# Access Compliance Report

## Public Rights-of-Way

Intersection ID: 2770	Main Street: BELL'S_MILL_DR	Cross Street: TARLAND_LN	Location: SW
ADA ID: CBE3B67EF6DB	Ramp Type: PerpDiag	Initial Pass/Fail: Fail	Overall Compliance: No
		Severity Score: 25

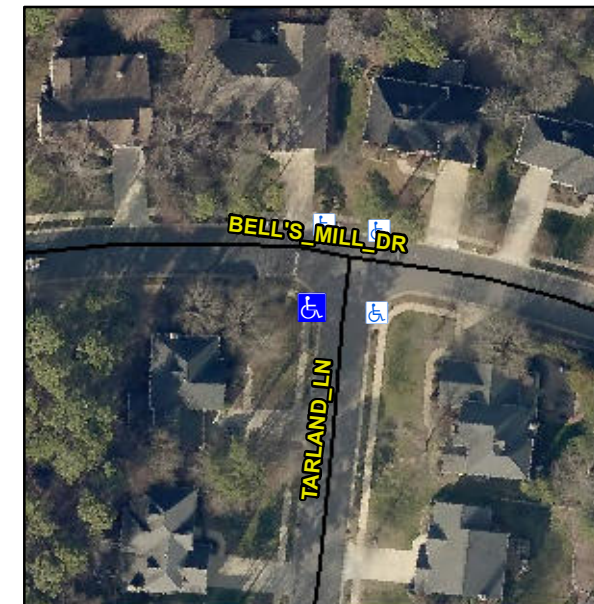
**Not Found, R304.2.2, R304.5.3**

Compliance	Description	Data	Compliance	Description	Data
N/A	Ramp Length (in)	47.0	No	Ramp Slope (%)	9.1
Yes	Ramp Width (in)	57.0	No	Ramp XSlope (%)	6.4
N/A	Flare Type LT	N/A	N/A	Flare Type RT	N/A
N/A	Flare Slope LT (%)	N/A	N/A	Flare Slope RT (%)	N/A
N/A	Flare Traversable LT?	N/A	N/A	Flare Traversable RT?	N/A
N/A	Landing Length (in)	N/A	N/A	DWS Provided?	N/A
N/A	Landing Width (in)	N/A	N/A	DWS Contrast?	N/A
N/A	Landing Slope (%)	N/A	N/A	DWS Length (in)	N/A
N/A	Landing X Slope (%)	N/A	N/A	DWS Full Width?	N/A
N/A	Landing Curb? (Y/N)	N/A	N/A	DWS Offset (in)	N/A
N/A	Shared Landing?	N/A			
N/A	Gutter Ponding?	N/A	N/A	Gutter Slope (%)	N/A
N/A	Gutter Lip Ht (in)	N/A	N/A	Gutter X Slope (%)	N/A
N/A	Painted X Walk1?	No	N/A	Painted X Walk2?	No
	X Walk 1 Direction	To E		X Walk 2 Direction	To N
N/A	X Walk 1 Width (in)	N/A	N/A	X Walk 2 Width (in)	N/A
	X Walk 1 Slope (%)	4.7		X Walk 2 Slope (%)	7.7
	X Walk 1 X Slope (%)	7.6		X Walk 2 X Slope (%)	2.0

**Remove & Replace Curb Ramp With Two New Directional Ramps or Equivalent.**
